- Request - Special Use Permit for Gasoline and Fuel Sales
- Location - 1322 Bernath Parkway
- Applicant + Design Professional - Matt Davis
CESO, Inc.
2800 Corporate Exchange Drive, STE 400
Columbus, OH 43231
- Developer - 7-Eleven, Inc.
3200 Hackberry Road
Irving, TX 75063
- Owner - Akaashaman, LLC
3550 Mowry Ave, STE 301
Freemont, CA 94538

SPECIAL USE PERMIT
TOLEDO CITY PLAN COMMISSION
REF: SUP25-0049
DATE: April 9, 2026
TIME: 2:00 P.M.

ELEVATIONS PLAN

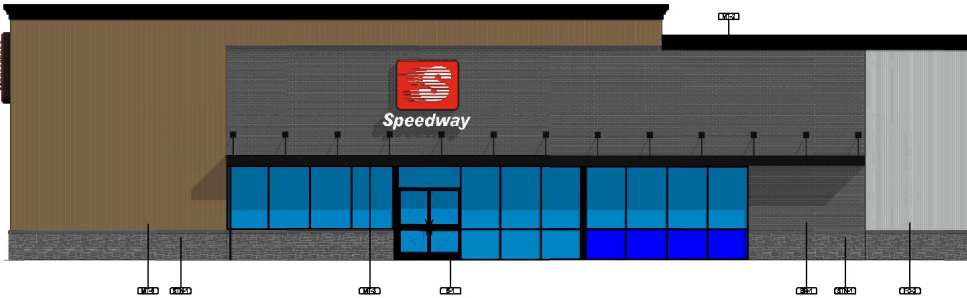
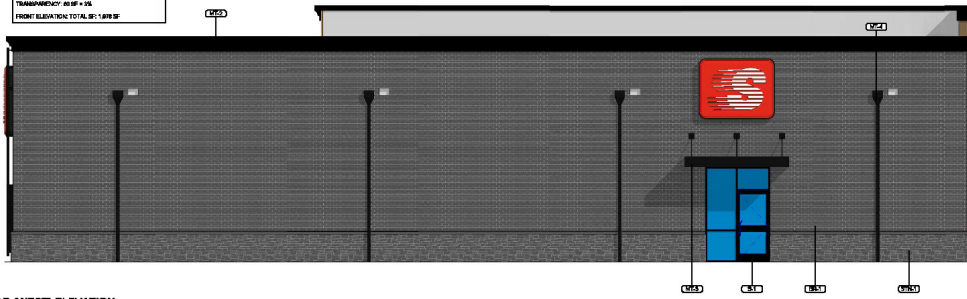
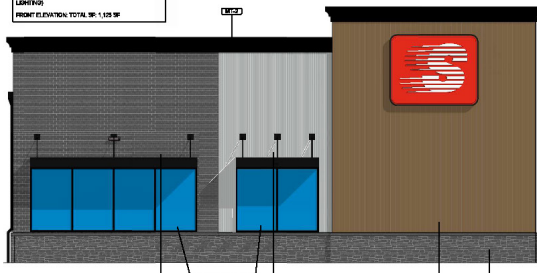
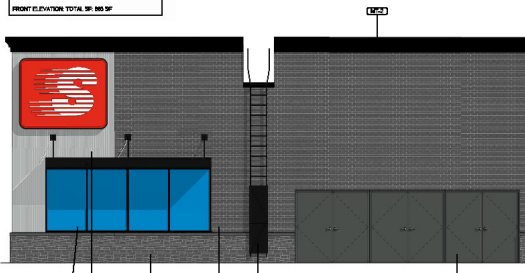
TMC§1109.0205 *Building Design Standards* requires variation in massing and wall articulation for facades facing streets and walkways. This section also requires the building’s design to reduce its perceived height by dividing the building mass into smaller scale components. The proposed building elevations meets these design standards through a variation of parapet heights, wall plane offsets, changes in texture and color of wall surfaces, use of windows with mullions, and a three-foot (3’) in height stone wainscoting. Additionally, transparent windows must occupy at least forty (40%) percent of the area between two (2’) and ten (10’) feet in height from the ground base of the primary elevation facing the right-of-way. For corner properties, transparent windows shall also occupy at least twenty (20%) percent of this area facing the side street. The primary building elevation facing east along Bernath Parkway proposes fifty-four (54%) window coverage between two (2’) and ten (10’) feet in height from the ground base. The south and north facades facing Airport Highway and Tibaron Lane depict window coverage of forty-one (41%) percent and twenty-seven (27%) percent respectively between two (2’) and ten (10’) feet in height from the ground base of the side elevations.

As required under TMC§1109.0500 *Building Façade Materials and Color*, all facades that are visible from the right-of-way must provide at least eighty (80%) percent of predominant building materials and no more than twenty (20%) percent accent materials. The submitted building elevations meets the regulations for *Building Façade Materials and Color*.

The proposed architectural metal is indicated as a twenty-four (24)-gage face sheet. Per TMC§1109.0502(D)(4) – metal panels shall have a minimum twenty-two (22)-gage face sheet. The use of twenty-four (24)-gage architectural metal is not permitted and is listed as condition of approval.

39. Per TMC§1109.0502(D)(4) architectural metal panels shall have a minimum twenty-two (22)-gage face sheet. **Not acceptable as depicted on building elevations.**
